**STAFF RECOMMENDATION**

**916 Acklen Avenue**

**April 22, 2020**

**Application:** New Construction—Infill

D-ELEVATIONS

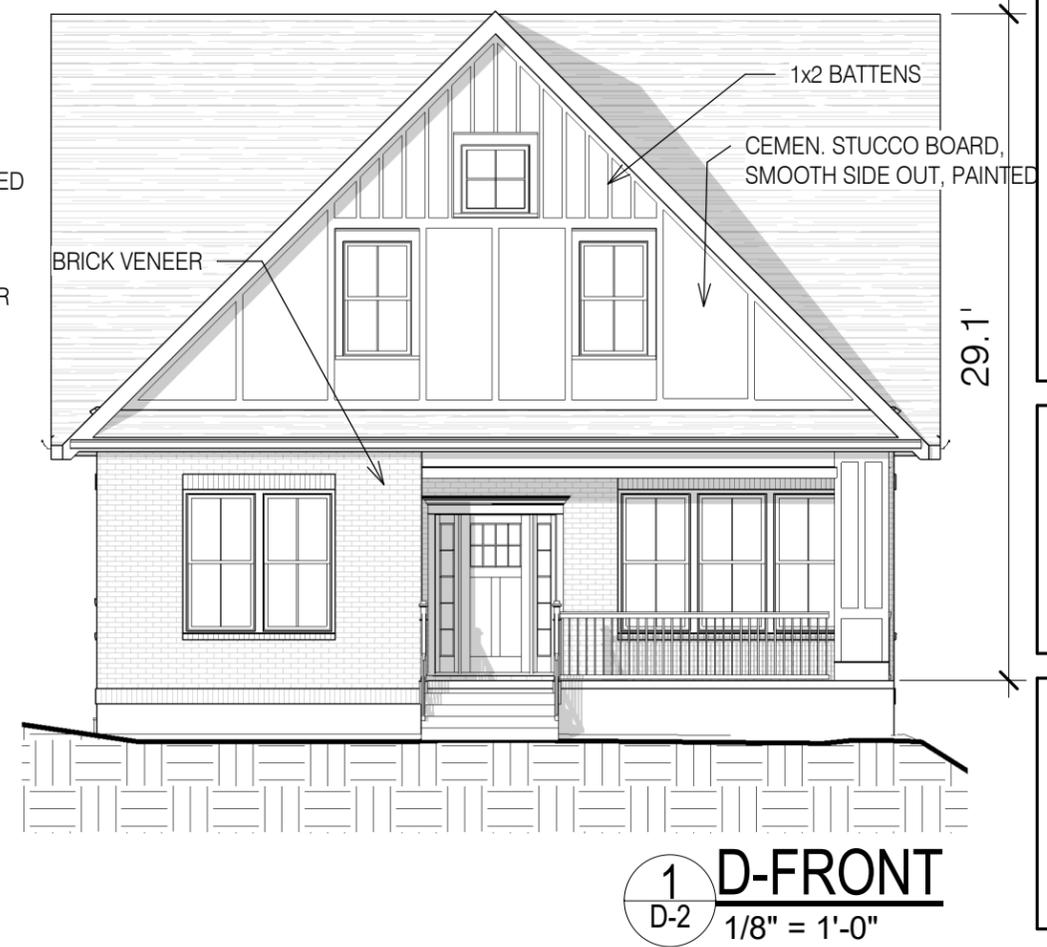
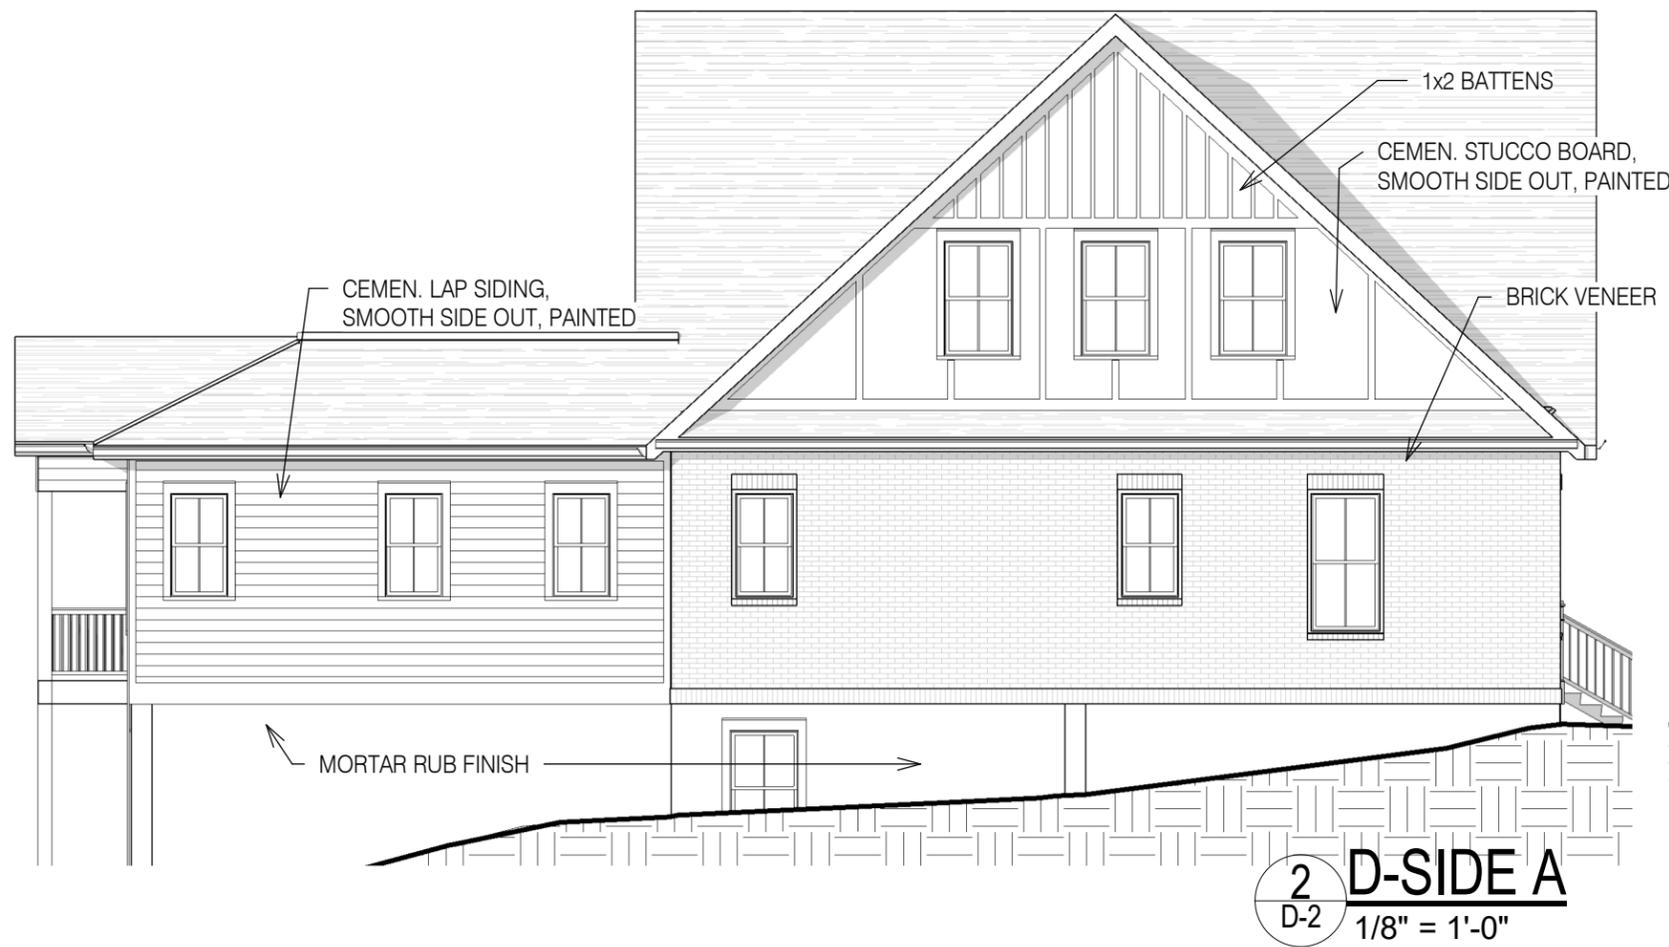
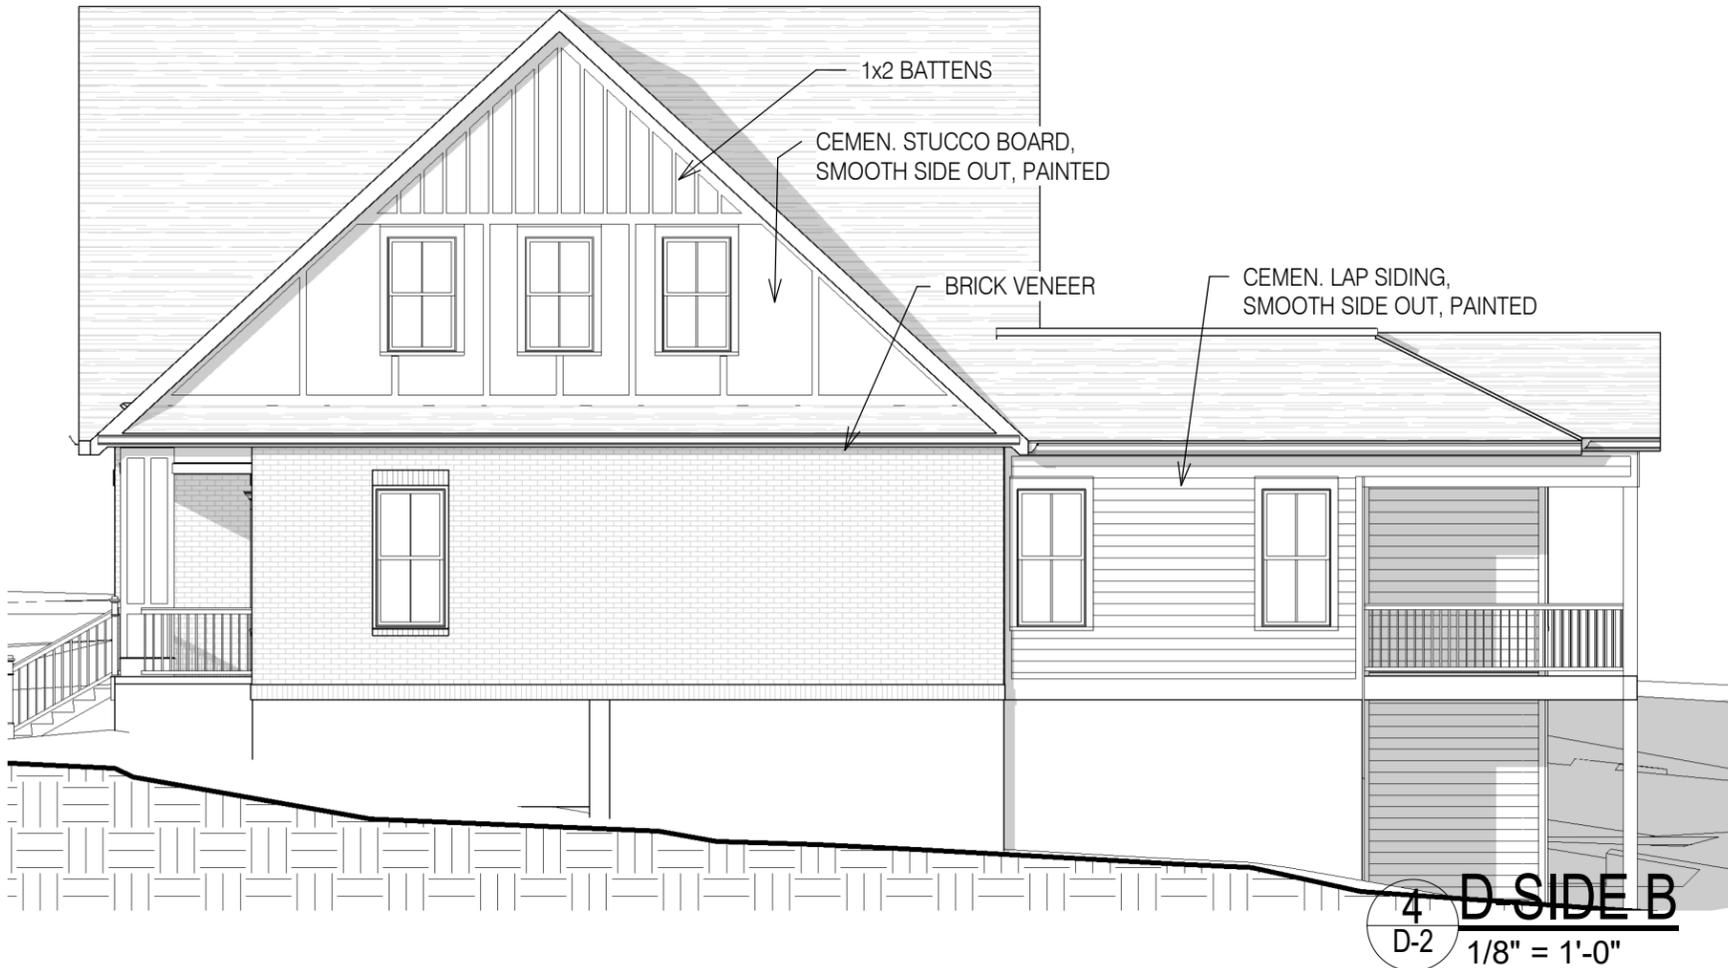
House D, which is one-and-a-half stories, has a cross-gable form as its primary roof form, with 11/12 and 12/12 pitches. It has an inset front porch.

Proportion and Rhythm of Openings: The windows on the proposed infills are all generally twice as tall as they are wide, thereby meeting the historic proportions of openings. Most of the facades do not have large expanses of wall space without a window or door opening, except the right elevations of House B and House D. Staff recommends that the right elevations of Houses B and D have at least one window additional window opening around the midpoint or towards the rear.

1. The finished floor height be consistent with the finished floor heights of the adjacent historic houses, to be verified by MHZC staff in the field;
2. At least one window opening of at least four square feet (4 sq. ft.) be added to the right elevations of Houses B and D, near the midpoint or towards the rear;
3. Staff approve the brick samples, all windows and doors, the roof shingle color and texture, and the walkway and driveway materials prior to purchase and installation; and
4. The HVAC be located behind the house or on either side, beyond the mid-point of the house.
